ADDENDUM NO. 1

May 31, 2023

Noblesville Ambulatory Surgery Center
14065 Borg Warner Drive
Noblesville, IN 46060

A-E2.01B

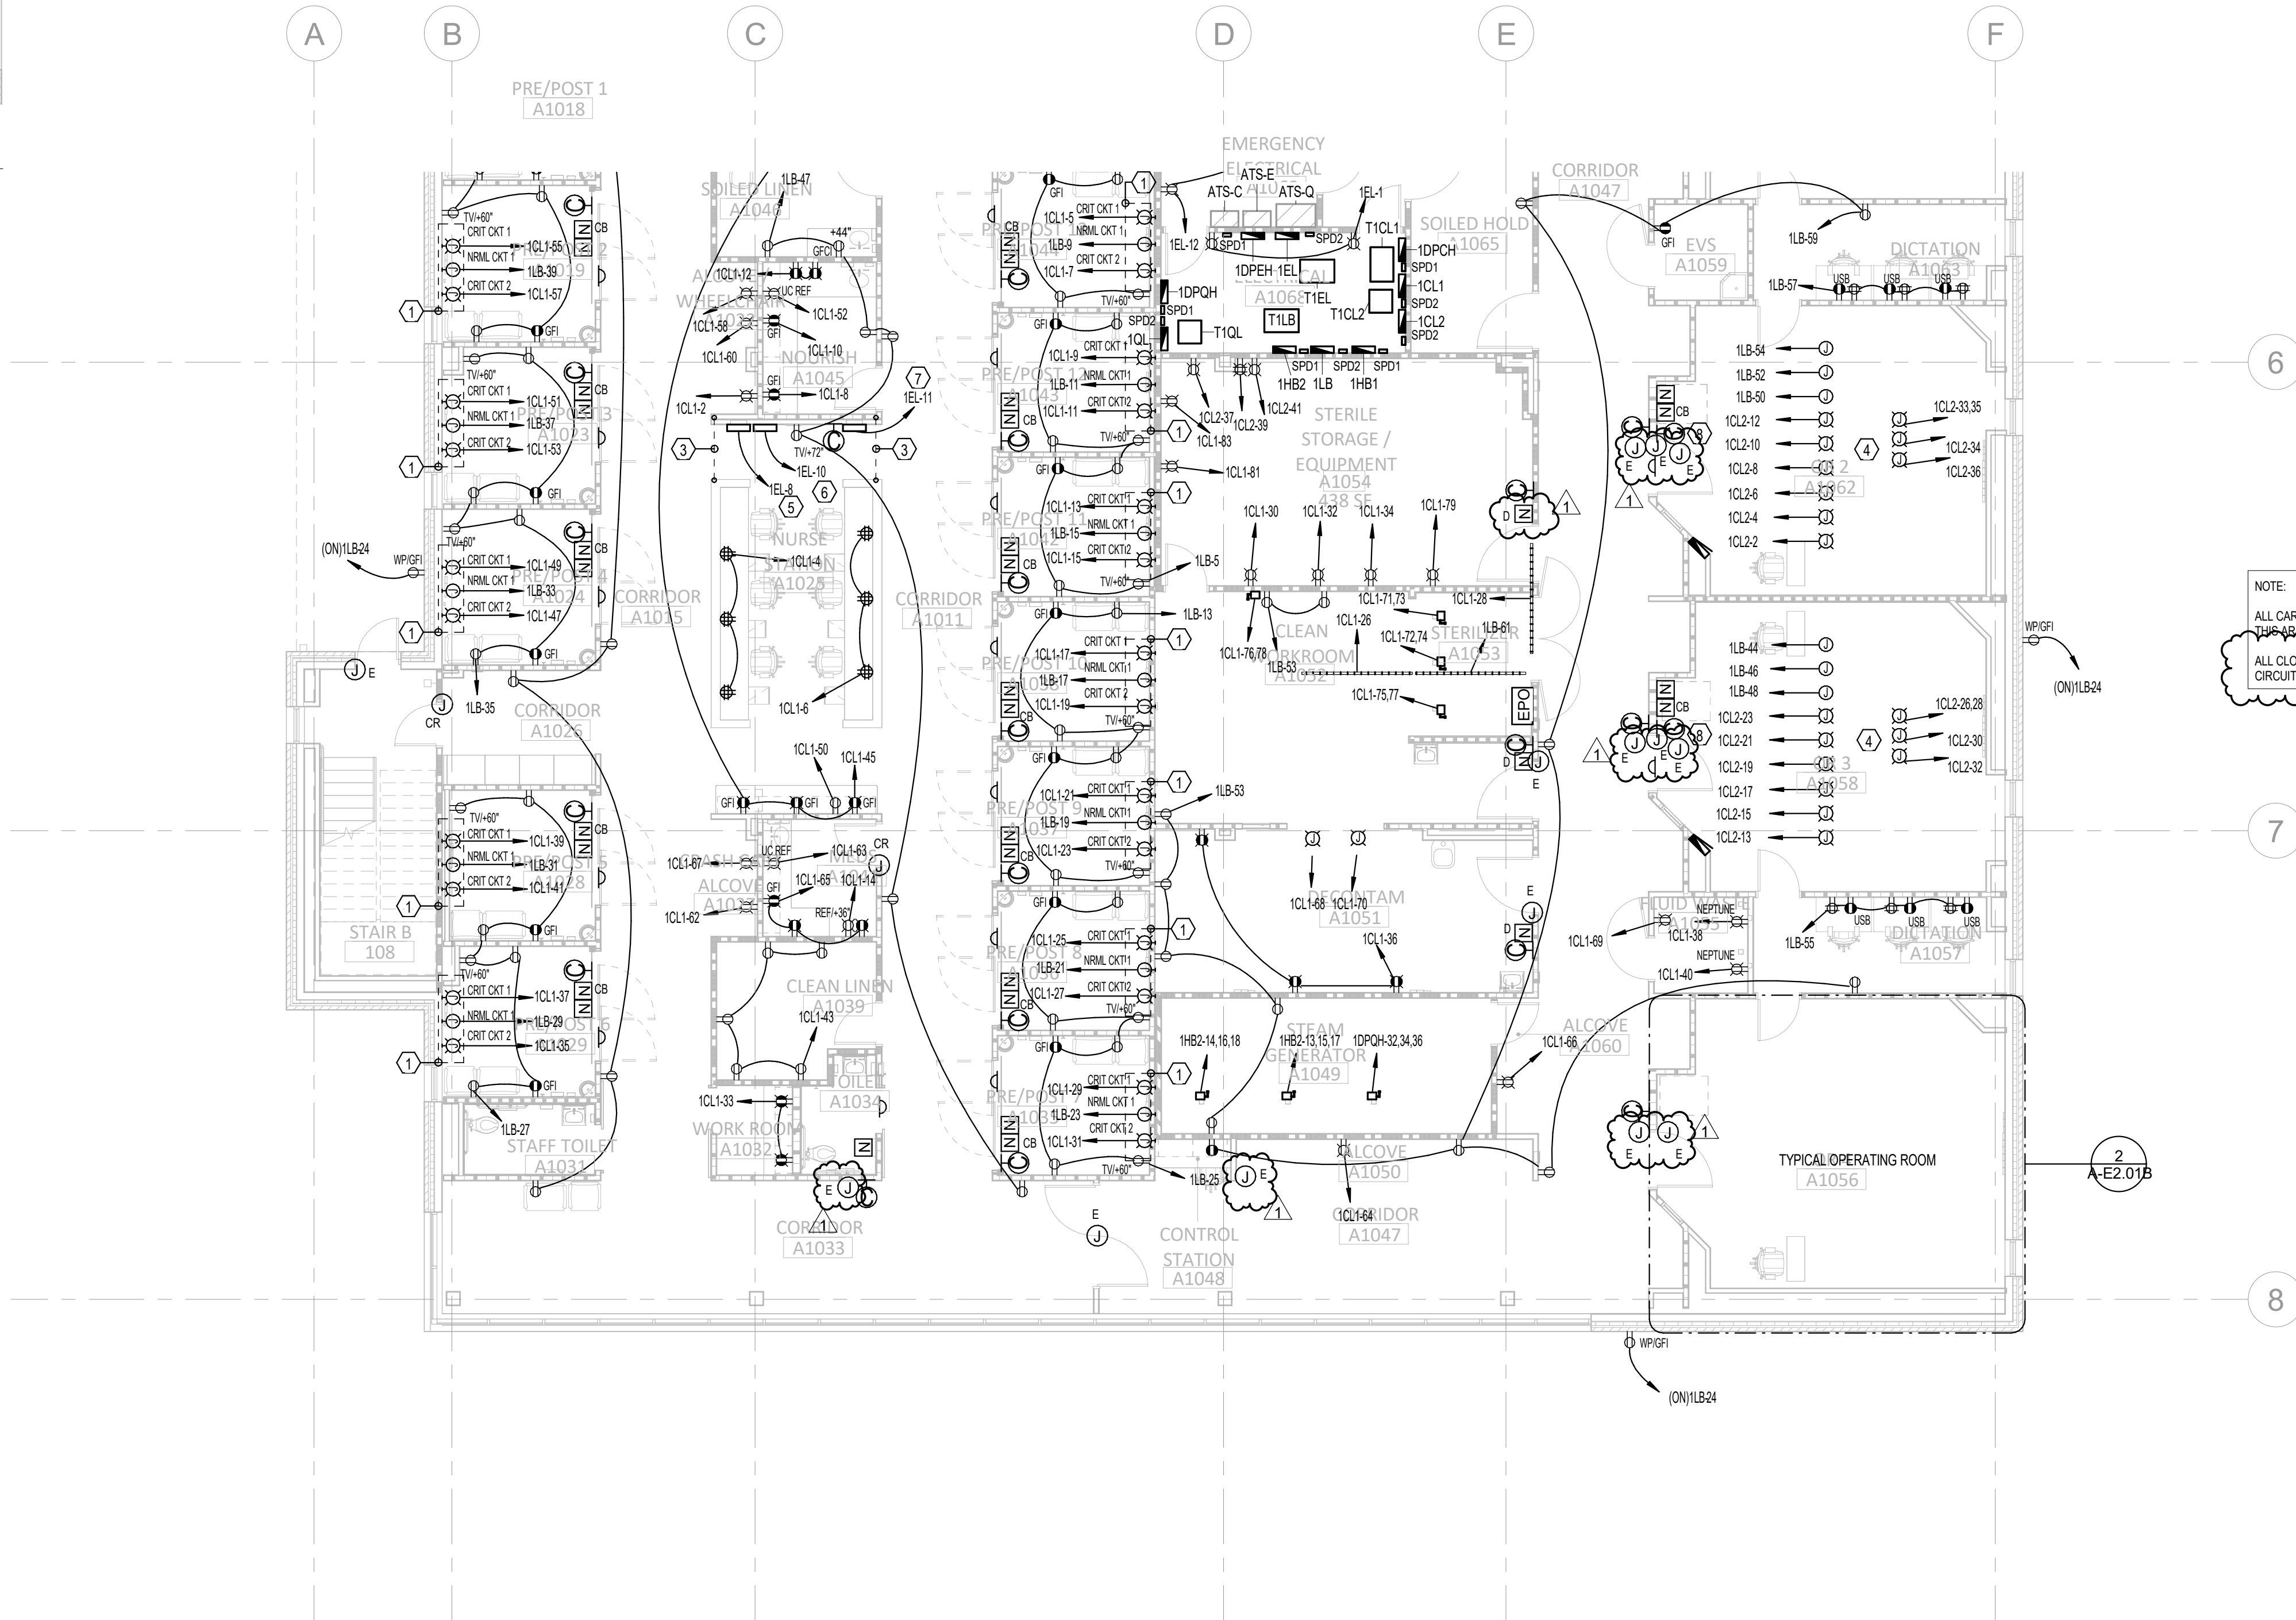
- A. Added junction boxes for power to door open buttons.
- B. Added (1) nurse duty station.
- C. Edited keyed note 1.
- D. Removed (1) clock.
- E. Added note for clock power circuit.

1 ELECTRICAL ONE-LINE DIAGRAM

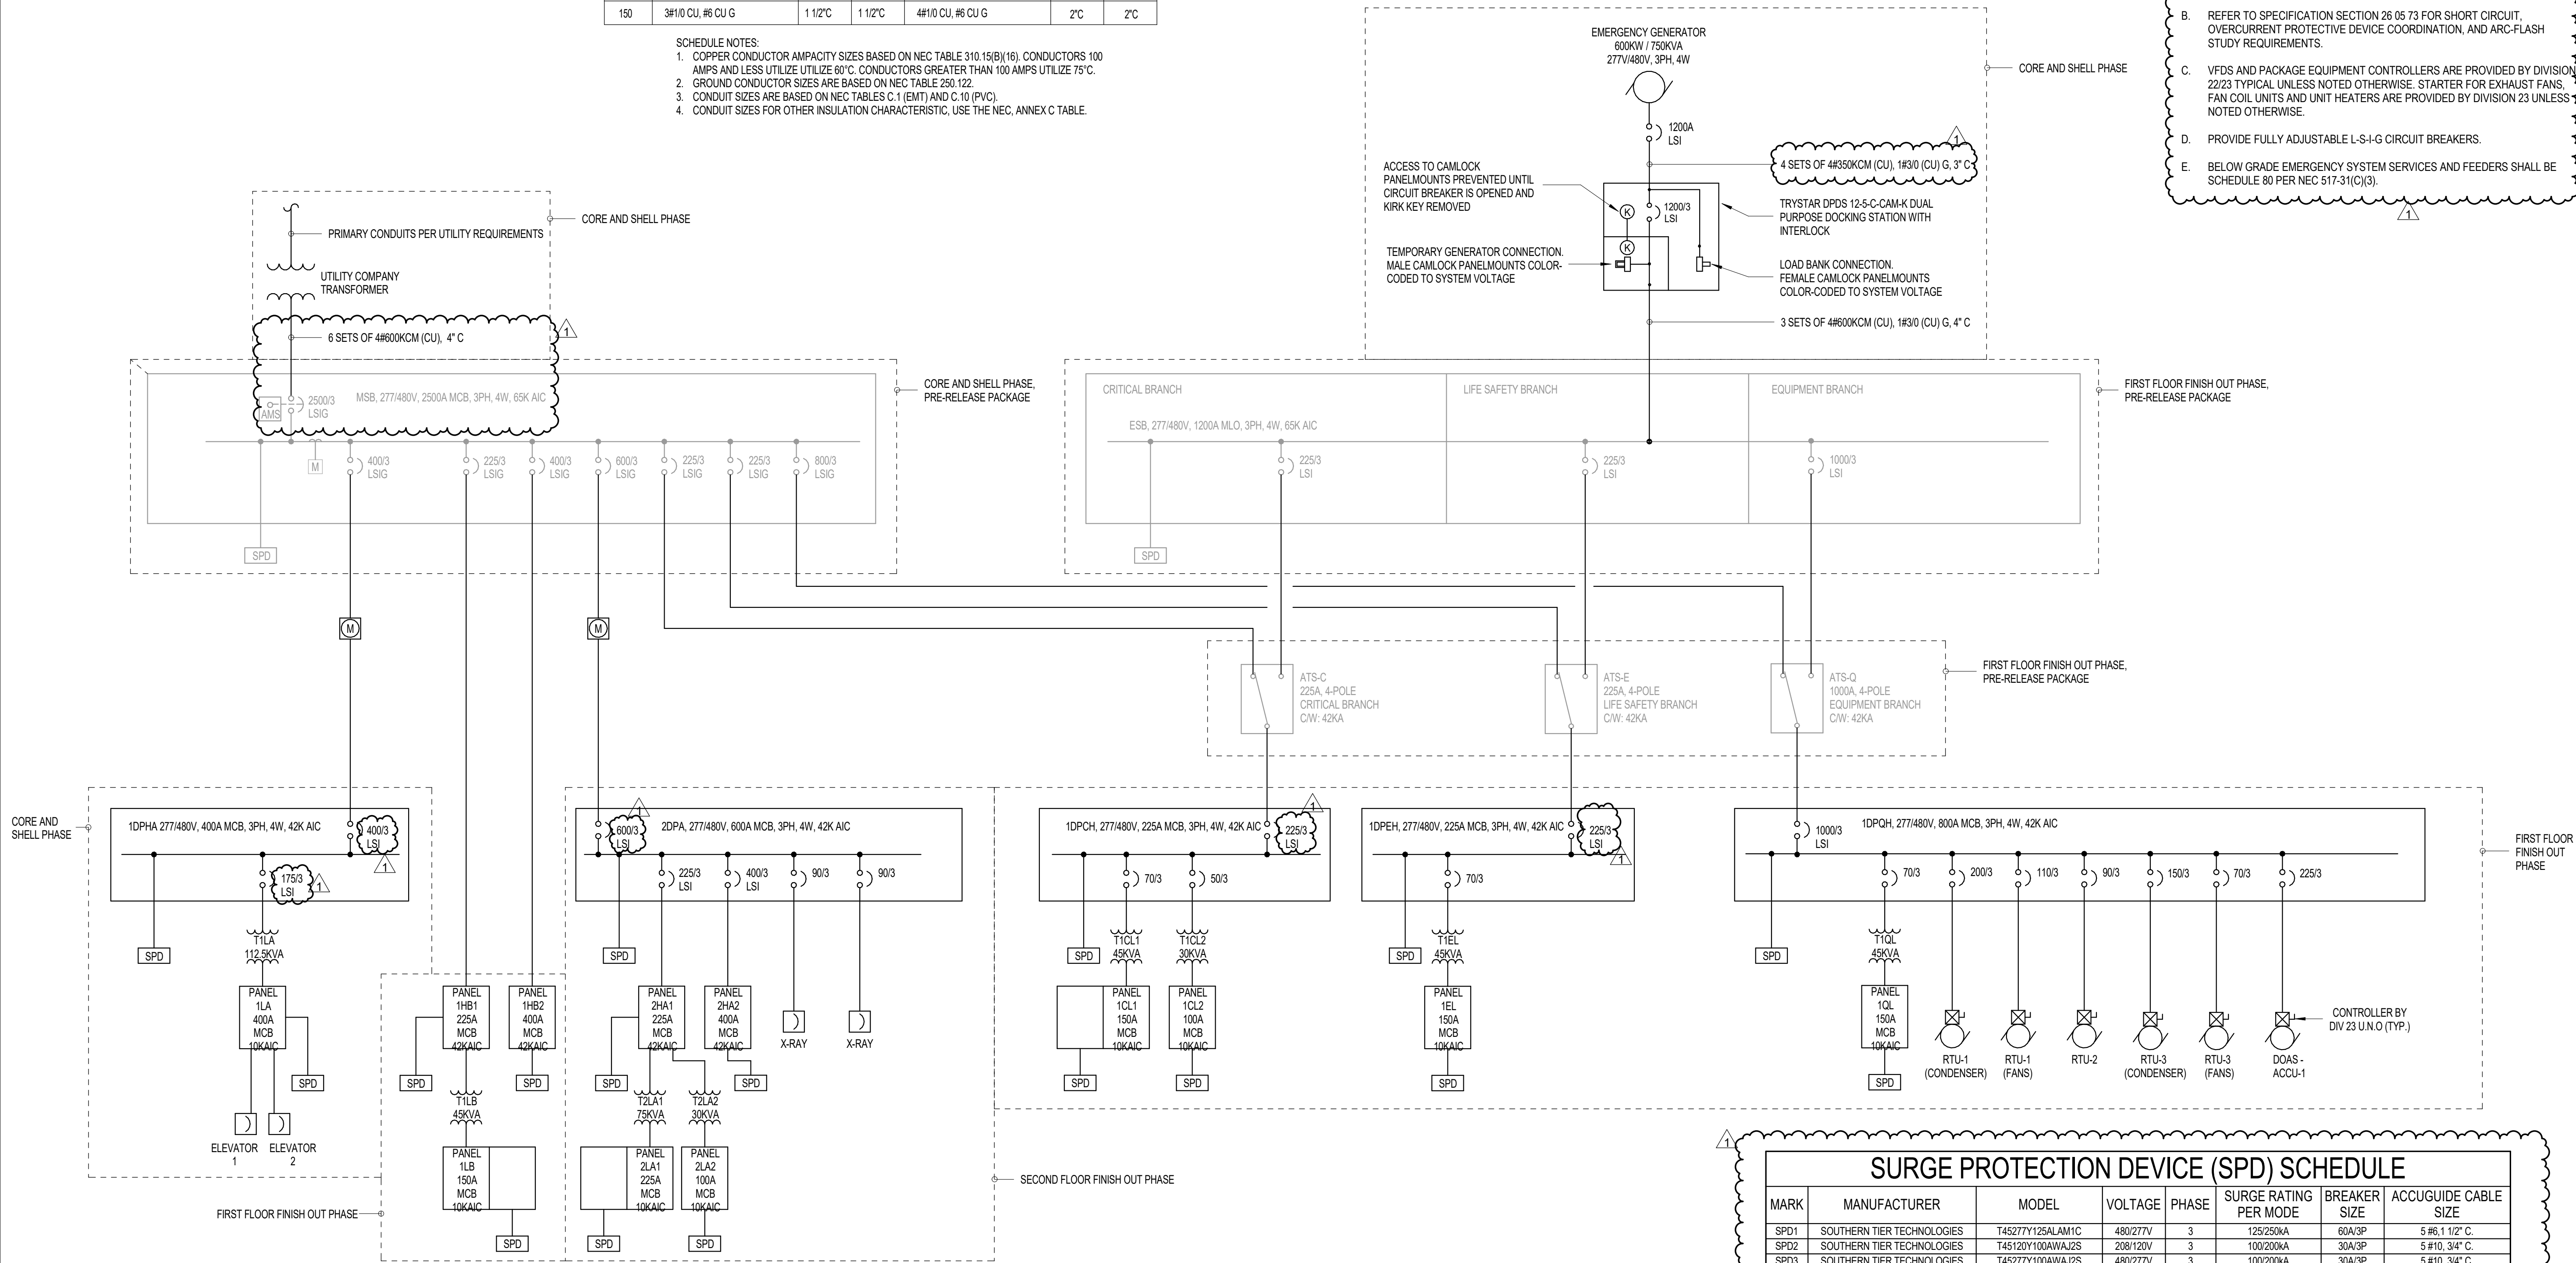
- A. Changed 225A breakers on the critical and life safety distribution panelboards to 225A LSI breaker types.
- B. Changed the 400A, 600A, and 175A breakers on the normal distribution panels to LSI breaker types.
- C. Added surge protection schedule.
- D. Edited service size to 2500A and feeder size to correspond.
- E. Edited generator feeder size.
- F. Edited general notes.

* INDICATES MINIMUM SIZE AT PLANTING.

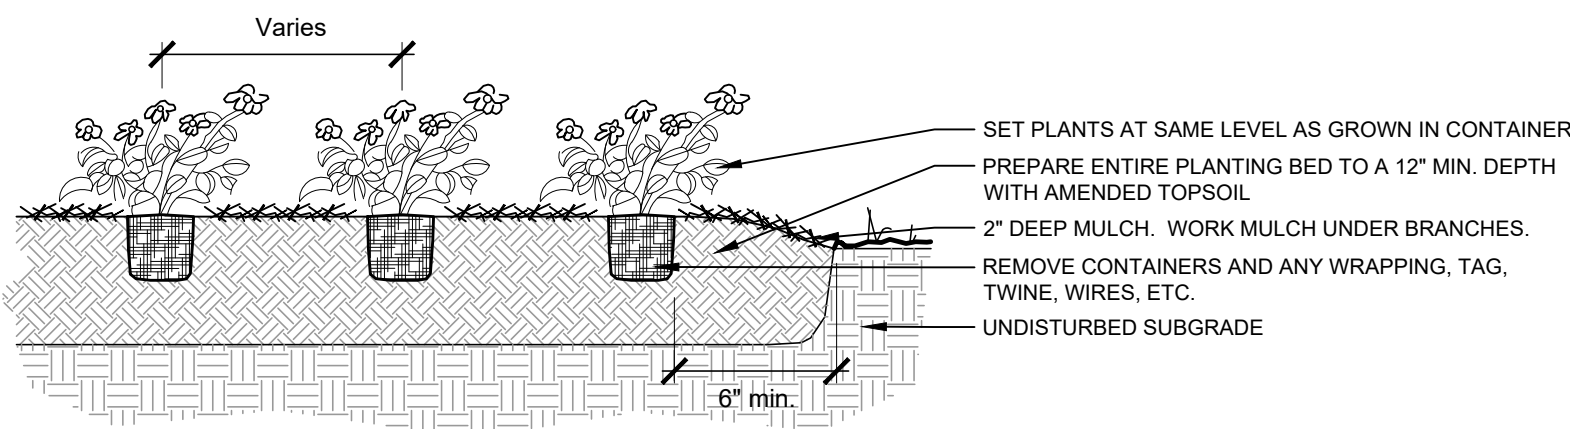
1. Added clarification that size* refers to minimum size at planting.
